Job Title:
115 EXMOUTH ROAD, RUISLIP, HA4 0UH

Drawing Title:
PROPOSED ROOF PLAN

Scale: 1:50 Date: 24/04/2024	Drawing No. PA3-2450-09	Print Size A3	Revision A
---------------------------------	----------------------------	-------------------------	----------------------

PROPOSED ROOF PLAN

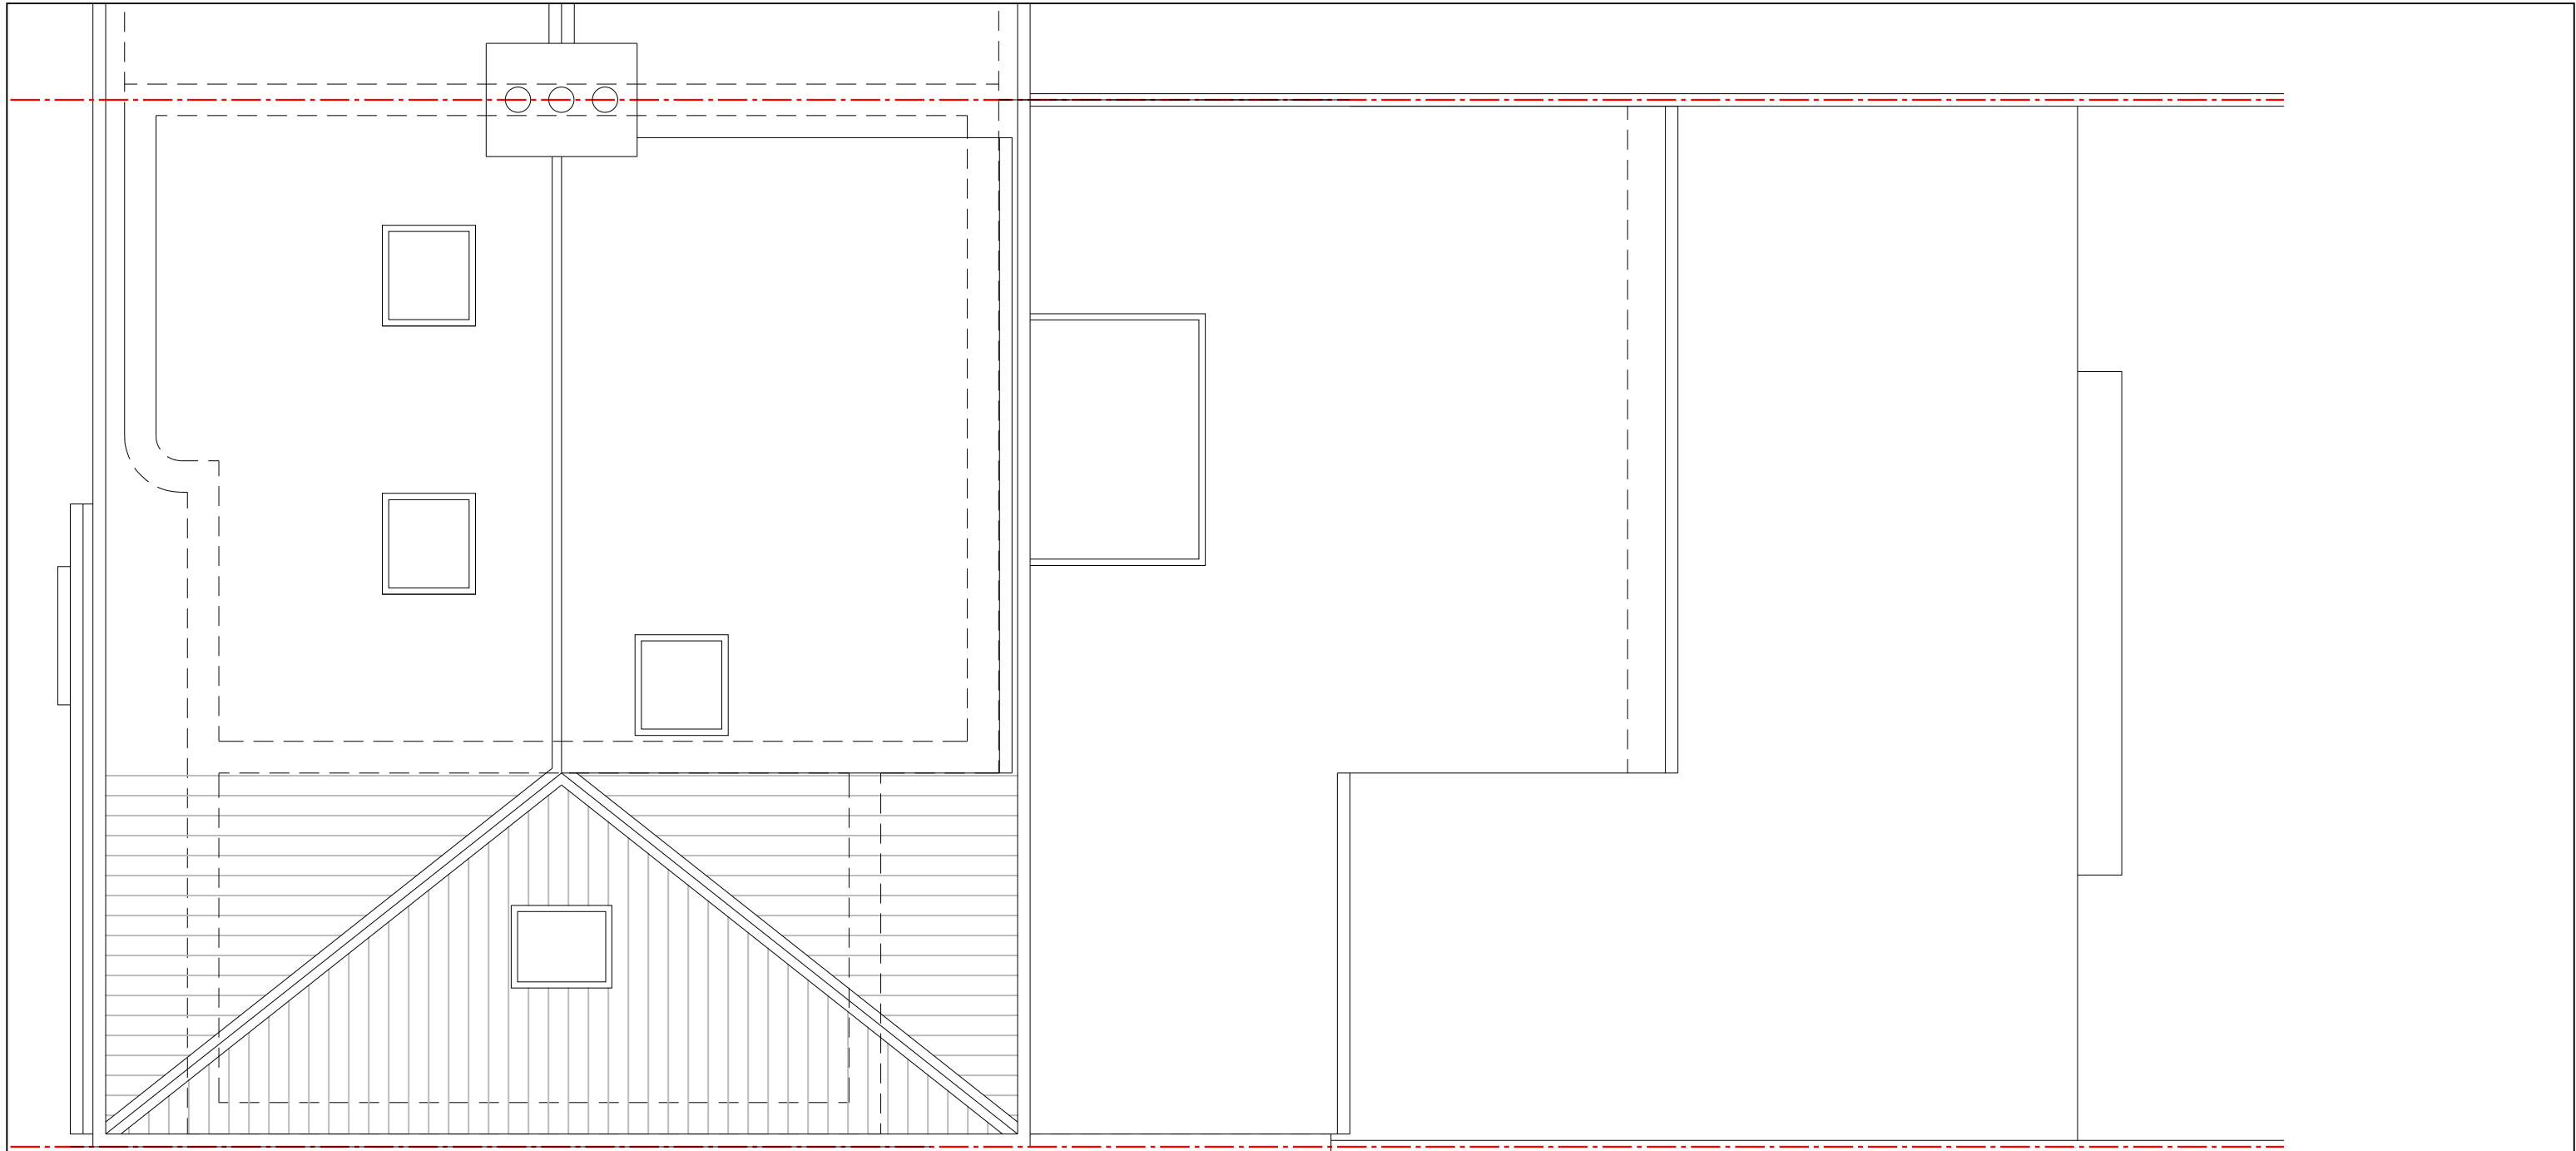
REV-A 25/07/16 NP Dwg revised as per case officer's advice.
